**Re: P2016-0049-CP - Comprehensive Plan; P2016-0049-ZCMA – Zone
Change; 8777 Washington Project**

This firm represents Arts District Residents for Responsible Development (“Association”). My client is aware that the City of Culver City (“City”) is considering a proposed development project located at 8777 Washington Boulevard and that the City has prepared a Mitigated Negative Declaration (“MND”) for the project pursuant to the California Environmental Quality Act (“CEQA”). For the reasons states below, my client contends that the MND is legally inadequate and that the City must conduct an Environmental Impact Report (“EIR”) for the project.

Figure 1 – Google Earth Screenshot Showing Closest Distance of Project Site to Metro Station.

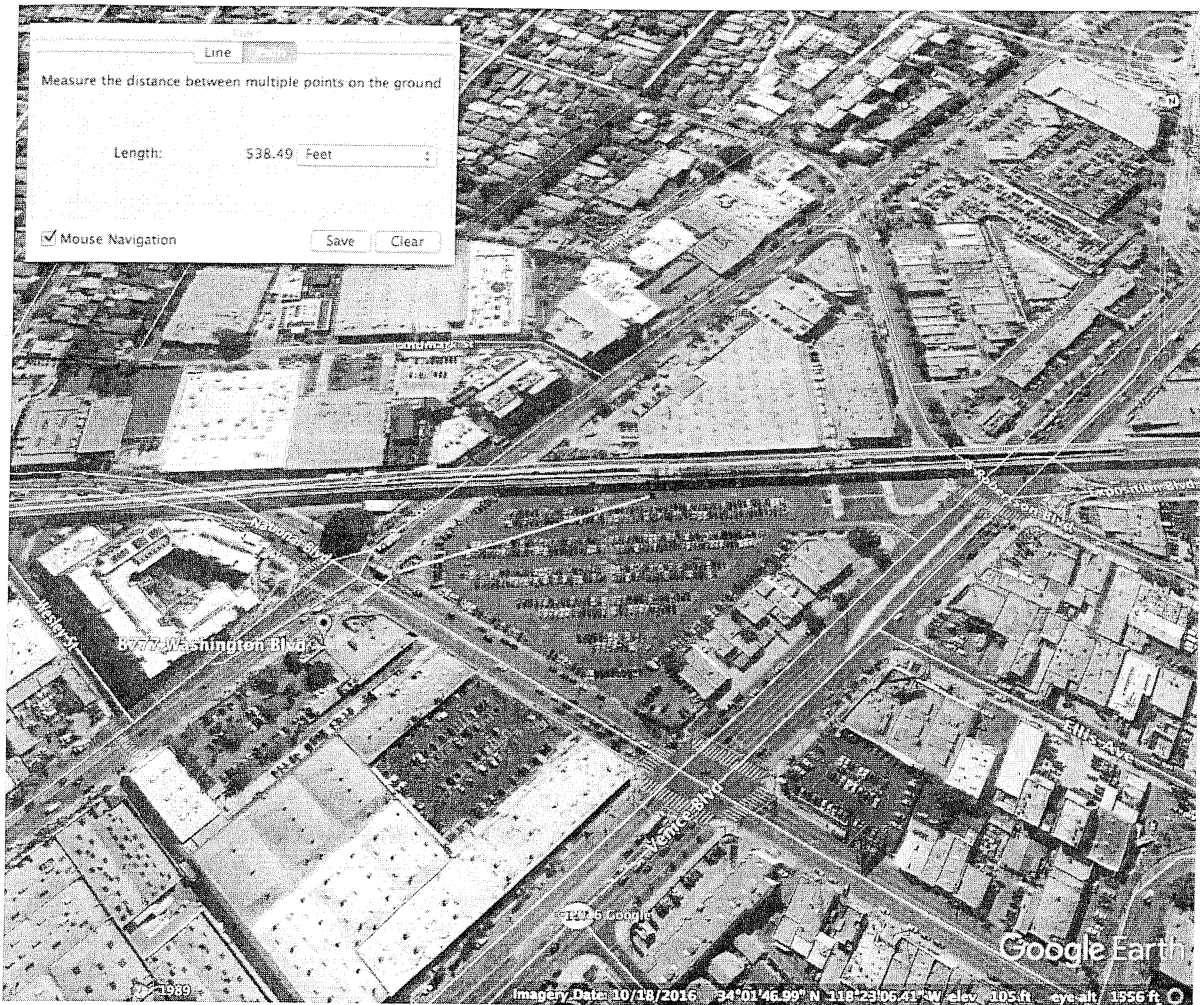
Based on the City of Los Angeles TIA Guidelines, the Traffic Study for the proposed project² inappropriately used a Transit Trip Use Discount of 25%. The proposed project is not located “above or adjacent to a Metro Rail, Metrolink, or Orange Line station,” as required for the 25% discount. As shown in **MND Figure A-2** (reproduced below), the project site is located across National Boulevard from the future Ivy Station Site, and is separated from the Expo Line Culver City Metro Station by National Boulevard and the Ivy Station Site (currently a parking lot). As shown in **Figure 1**, below, ignoring future development of the existing parking lot and assuming the most direct walking route, the project site is located at least 539 feet from the Metro station.

Because the project site is within ¼ mile of the Metro Station, the project is eligible for “up to a 15% trip generation adjustment.” As noted in the City’s Transportation Impact Study Guidelines, the actual adjustment should be determined by an analysis of the transit service frequency and density at the specified transit station or RapidBus stop. To obtain the maximum trip generation adjustment, Development Projects should include the types of improvements listed in the City of Los Angeles’ TIA Guidelines. The MND needs to provide an analysis to determine the degree to which the proposed project is eligible for the “up to 15% trip generation adjustment.” At most, no more than a 15% reduction would be appropriate.
